Comments regarding the report ‘Observation of abundant heat production from a reactor device and of isotopic changes in the fuel’ by Levi et al.

Per Rutquist

December 8, 2014

Figure 1: The circuit diagram from Figure 4 in the report [1].

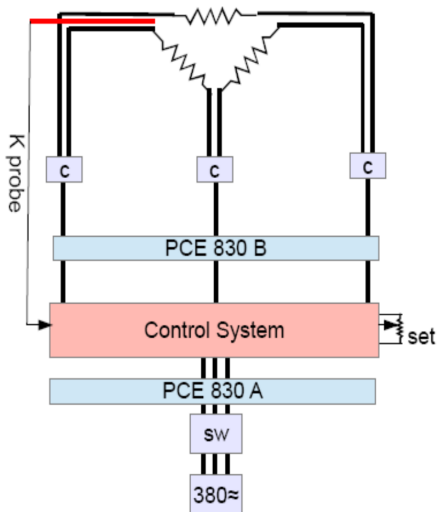
The experimental set-up is described using the circuit diagram in Figure 4 of the report (reproduced here in Figure 1). It shows the “reactor” as containing three resistors in a Delta configuration.

The result $I_2 = I_1/2$ is highly remarkable. Any basic textbook on three-phase systems will state the relationship between line and phase current in a balanced Delta-configuration as $I_2 = I_1/\sqrt{3}$. (See, for example, page 3-13 in reference [4].) Granted, most of those books assume a sinusoidal waveform and a resistive load, but it is relatively easy to show that for *any* type of waveform

and *any* type of load or source, the inequality $I_2 \geq I_1/\sqrt{3}$ holds. (A proof is given in appendix.) The relative difference between 2 and $\sqrt{3} \approx 1.73$ is much larger than the uncertainty of the measurements. The measured $I_2 = I_1/2$ is thus mathematically impossible!

The first conclusion is that the measurements that have been performed of the currents I_1 and I_2 during the “dummy” run cannot be reconciled with the presented circuit diagram. Therefore, none of the electrical measurements are credible, and there is no reason to assume that the observed heat production is due to anything other than electrical heating.
